BENNETT STREET, MANCHESTER

DISCHARGE OF CONDITION 11A PLANNING PERMISSION 134504/FO/2022

RESPONSE TO EA COMMENTS RECEIVED 19TH APRIL 2023

Waters Conceptual
Site Model

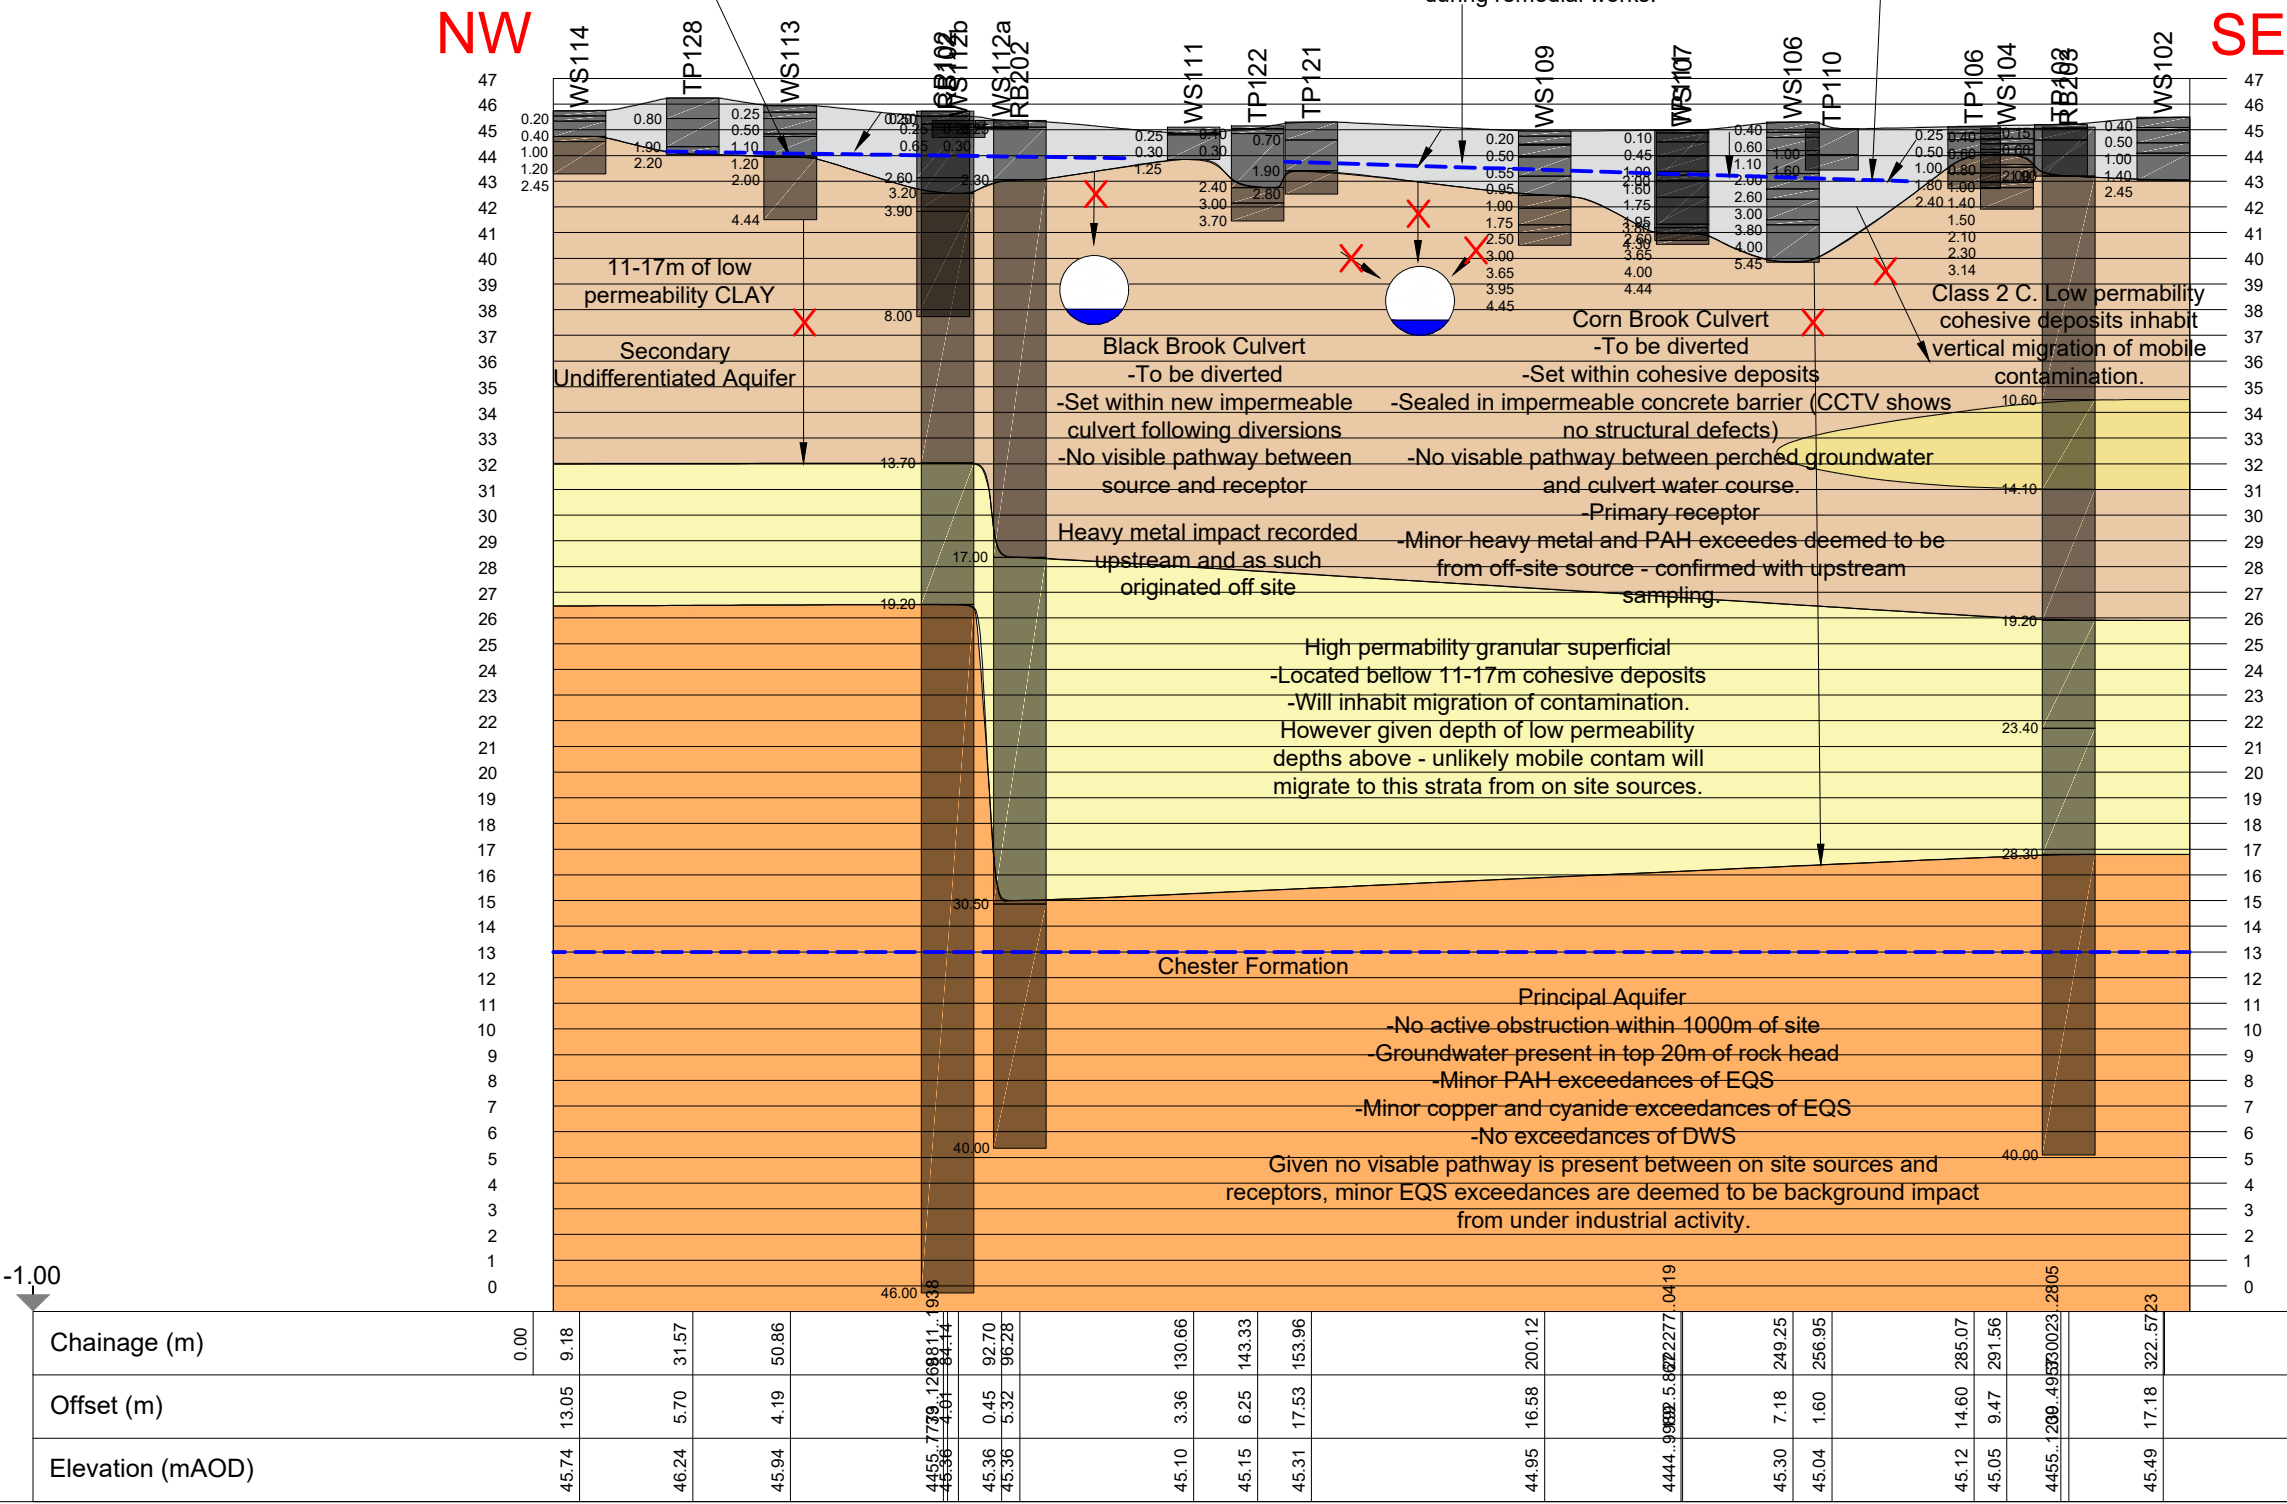
Arising from previous phases of work associated with the site and as aforementioned above, we are aware that two sub-surface/culverted ordinary watercourses intersect the site. We note some sampling has been undertaken of these watercourses which has found them to be impacted by contamination. We note the contaminant profile of watercourse sampling undertaken is similar to that which has been identified within the soils and the shallow groundwater sampling undertaken on-site.

Action [2] – Additional Watercourse Sampling & Consideration to Sub-Surface Culver Condition

As part of this assessment, E3P has completed a review of the site hydrogeology inclusive of additional sampling at upstream locations for both culverts, resulting in the development of an updated conceptual site model specifically related to controlled waters.

This model is attached to this letter for review by the EA to aid in their understanding of the site issues, completed remediation works (source removal) and mitigation in the form of new build phase works to ensure the protection of the viable receptors.

027

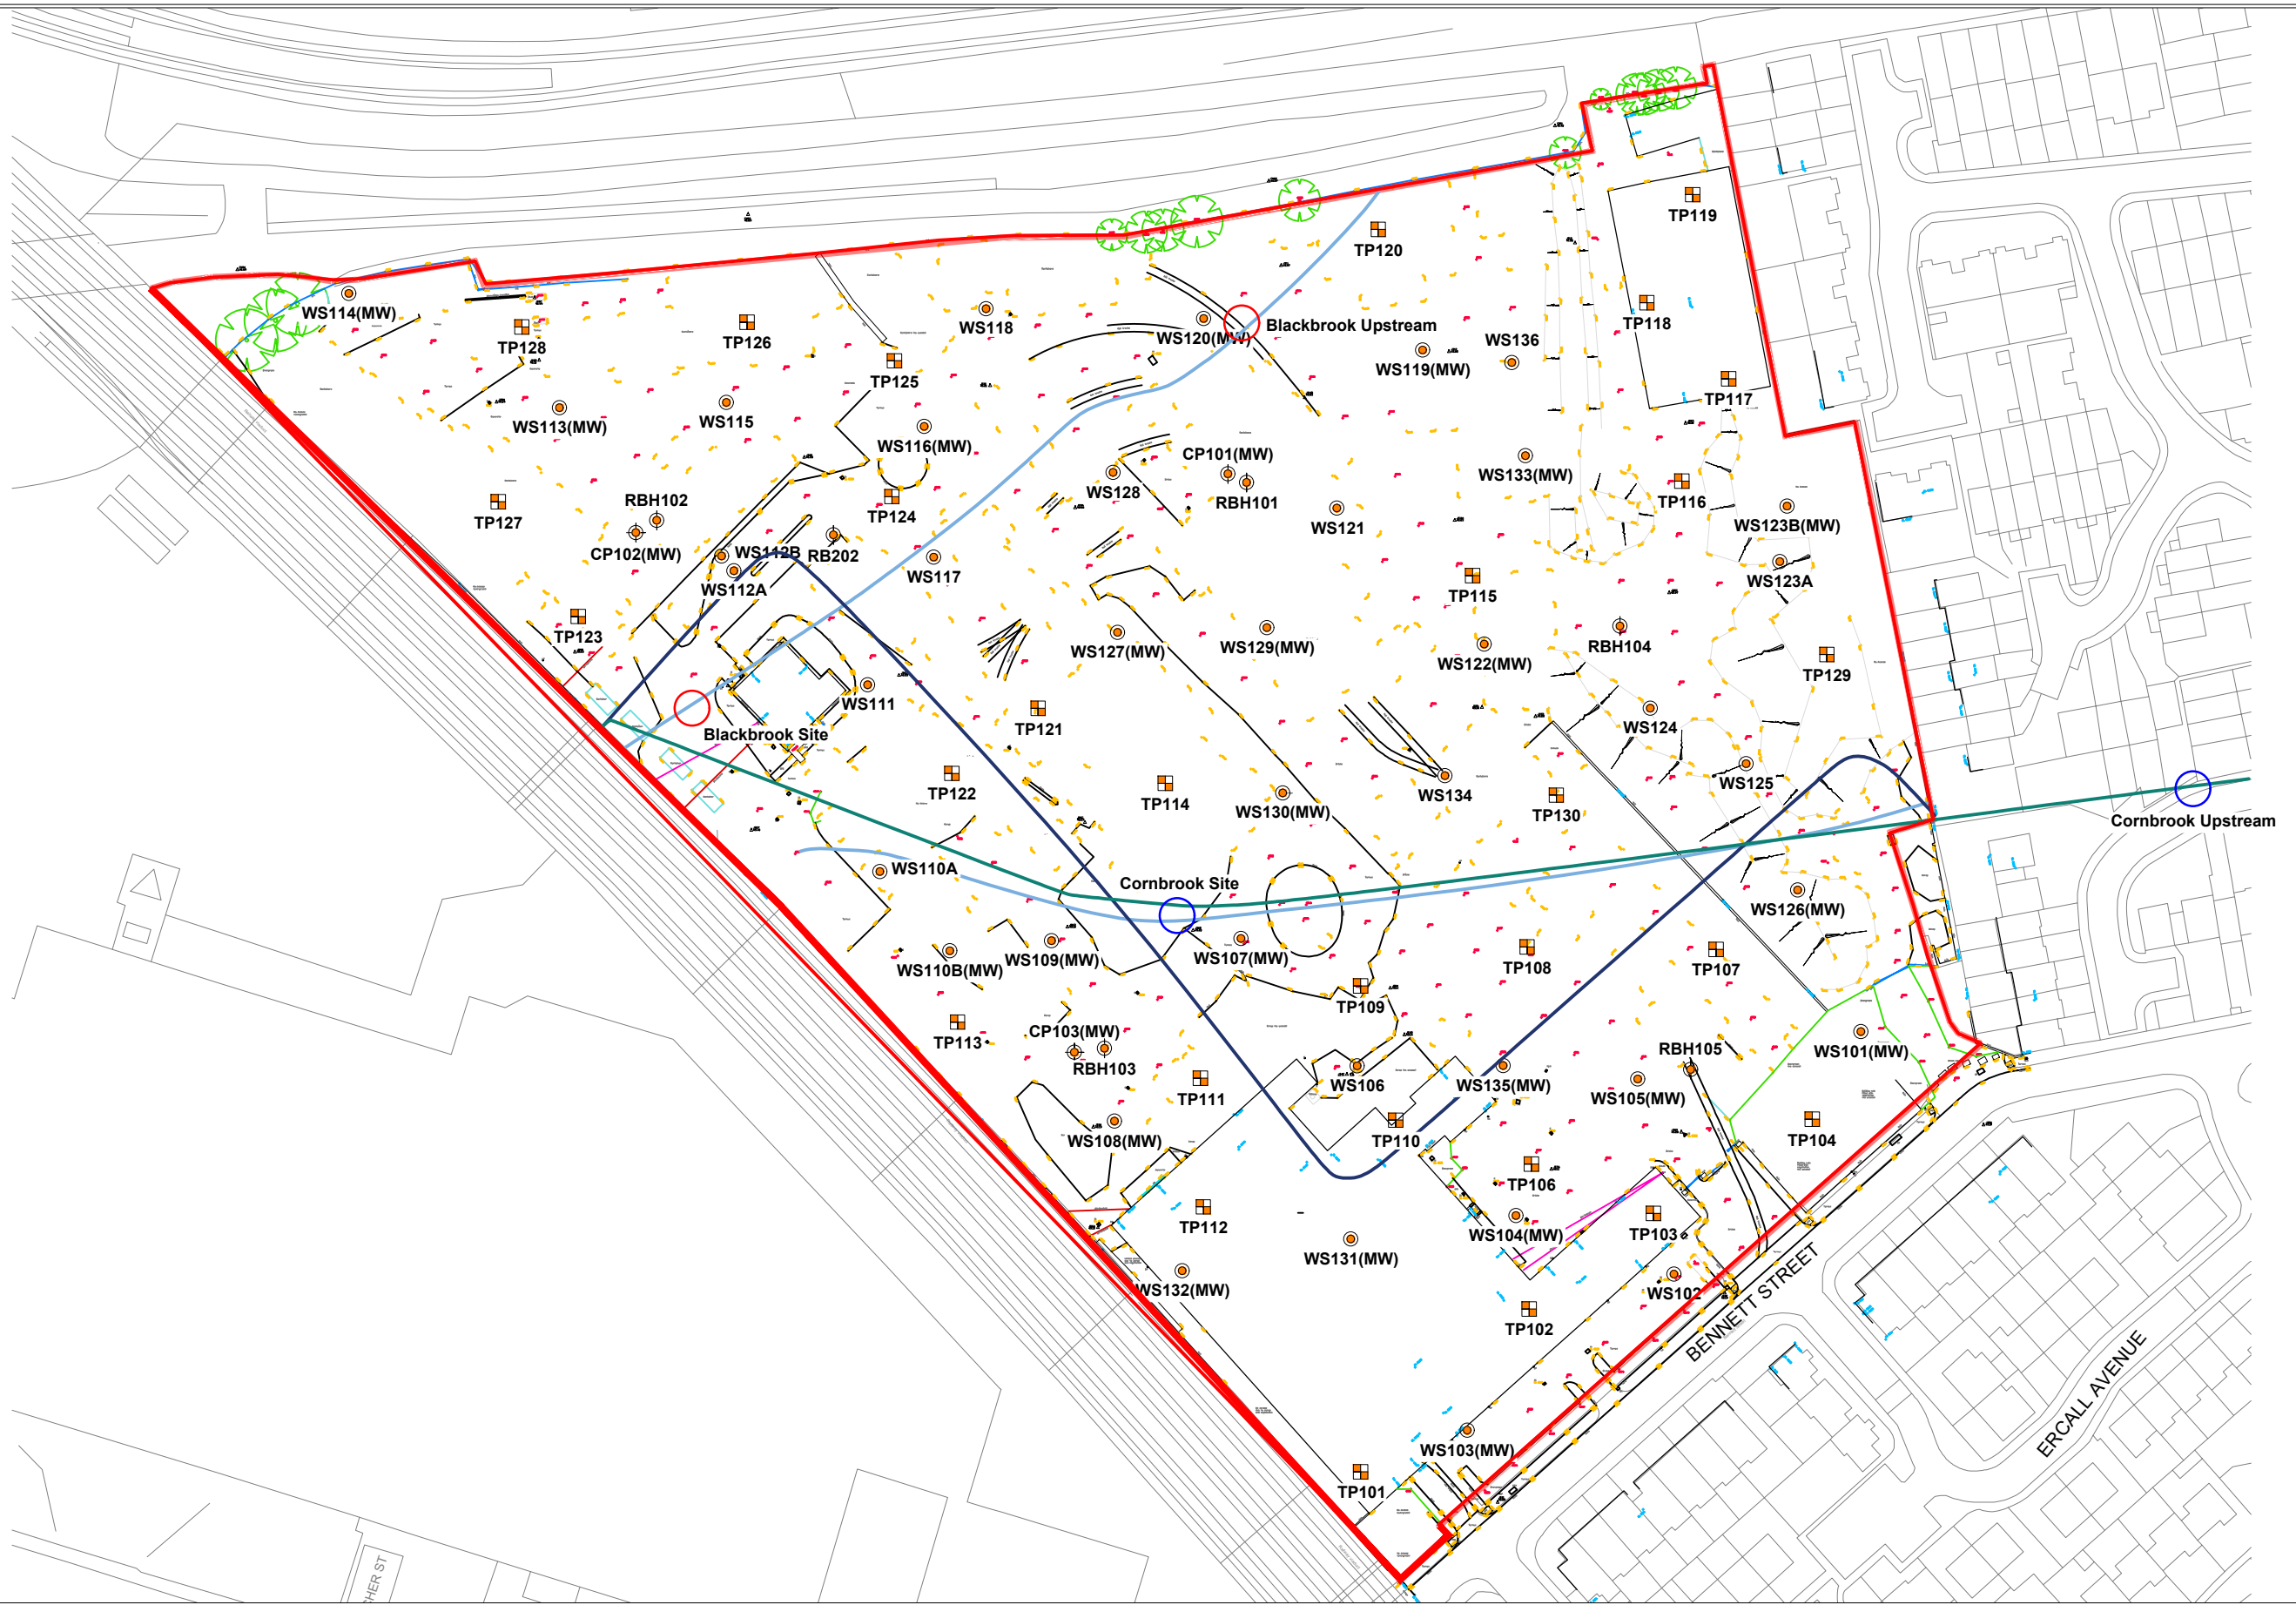
EA We have reviewed the surface watercourse information and identified that whilst SW3 is located on plan No. 11, that the corresponding lab results have not been included. We ask that confirmation is provided as to whether SW3 was sampled and, if yes to this question, requests that the results of this sampling activity are provided – noting this sampling location is situated upstream (Corn Brook) and our previous commentary regarding potential receptor linkage.

SW3 was not previously sampled during the previous E3P ground investigation, given no access to Corn Brook culvert was available in this location as anticipated.

A updated upstream sample location was identified as a manhole on Hayfield Close to the east.

E3P attended site in April 2023 and obtained samples from upstream and on site locations for both Black Brook and Corn Brook to accurately assess the risk to controlled waters, the findings of this are discussed above.

The location of recent water samples obtained in April 2023 is given on E3P Drawing 15-974-027 appended to this letter.

SAMPLE LABEL	TP301 1.5m	DATE SAMPLED	28-Apr-23
LAB SAMPLE No	124835	DATE RECEIVED	28-Apr-23
DATE TESTED	02-May-23	SAMPLED BY	Client

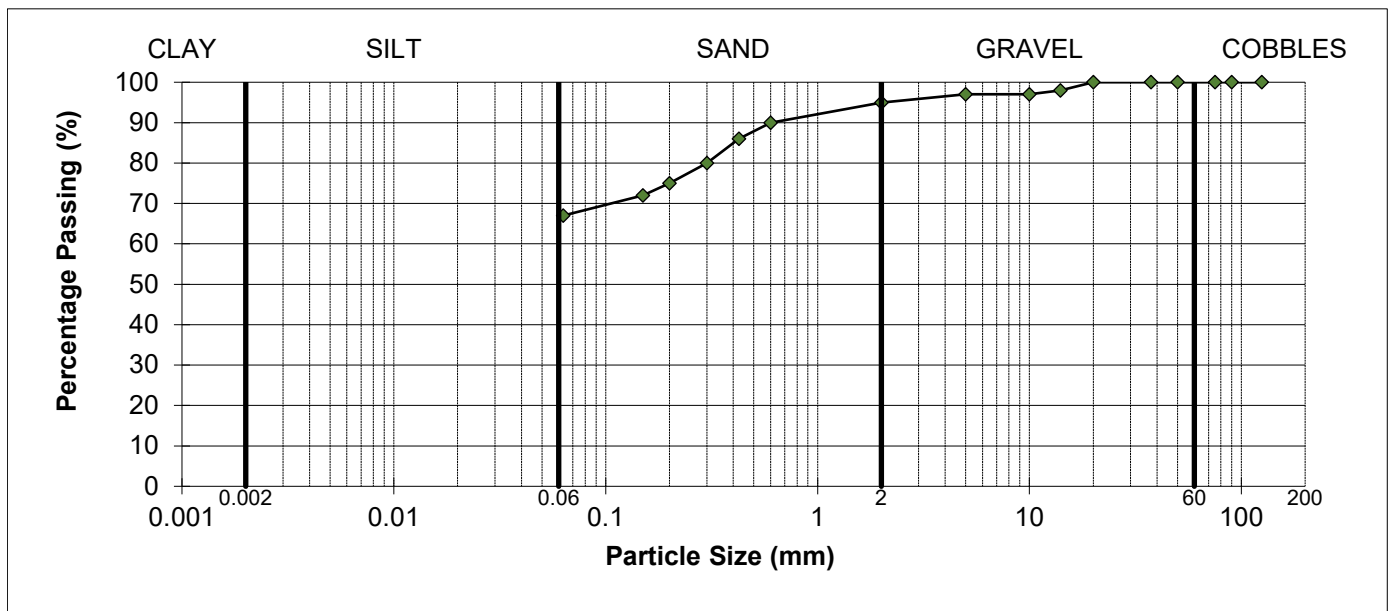
As update to the current e3p ltd report subject of this review, please can we request Particle Size Distribution Curves are provided that support the British Standard 5930 assessment of the site.

Action [1] - Provision of Particle Size Distribution Curves

E3P attended site on 2nd May 2023 to obtain additional geotechnical samples of Made Ground and natural soil below the site. PSD analysis of natural clay soils (TP301 at 1.50 m bgl) classified soils as Class 2B in line with Manual of Contract Documents for Highway Works (MCHW) series 600. Results of PSDs are appended to this letter as MRN 4588/45.
